21/1054/RES Hill Barton

9th August 2021

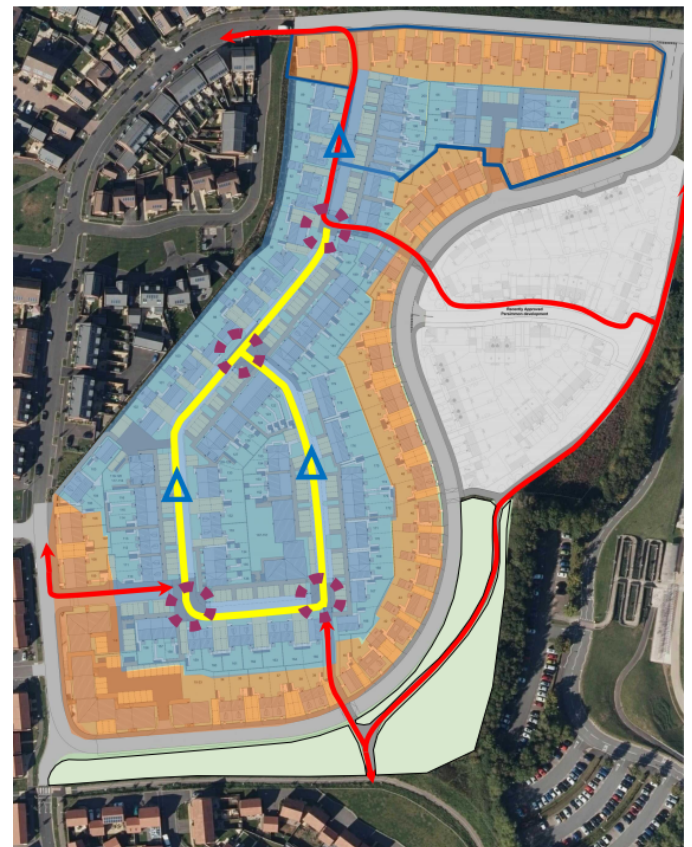
We welcome the Applicant's attempt to create an area which is permeable for people walking and cycling. This is welcomed.

The Design and Access statement states that "*These [Neighbourhood Core] areas prioritise pedestrians*". It is not clear how this prioritisation is being achieved. There appear no dedicated walkways for people to walk, the 'shared surfaces' are flanked with car parking and there appears no proposal to stop the shared squares from becoming car parking plots, as they have in other recent developments in the city.

Figure 10.6: Cycle priority crossing

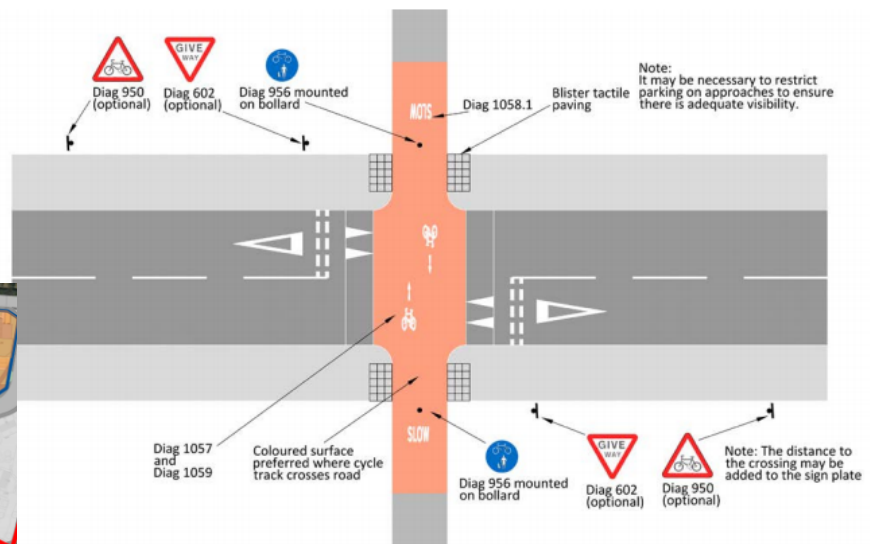
For the dedicated cycle route to be of use to people cycling they must have priority when crossing the road around the SE periphery of the development. A mere speed bump will not achieve this.

provides guidance on the design for this. (See figure 10.6 from LTN 1/20). We would ask for confirmation that people cycling will have a safe, priority crossing over the periphery road.

Modular semi vertical bike rack

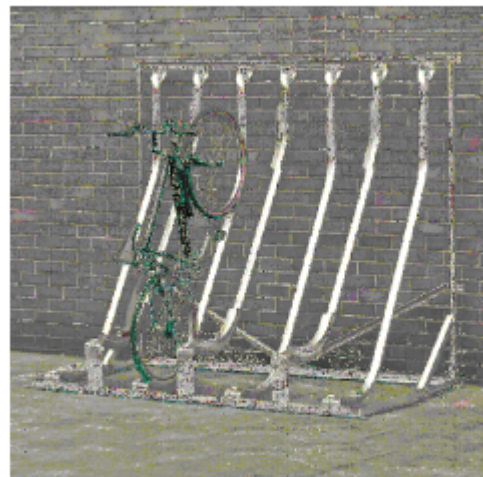
In addition, semi-vertical bike racks are of a poor design: they don't meet disability standards and don't hold bikes securely / without damaging bikes. LTN 1/20 recommends Sheffield or 'M-profile' bike racks and states that cycle racks that "*do not allow the frame to be secured should not be used*". (See LTN 1/20 section 11.4)
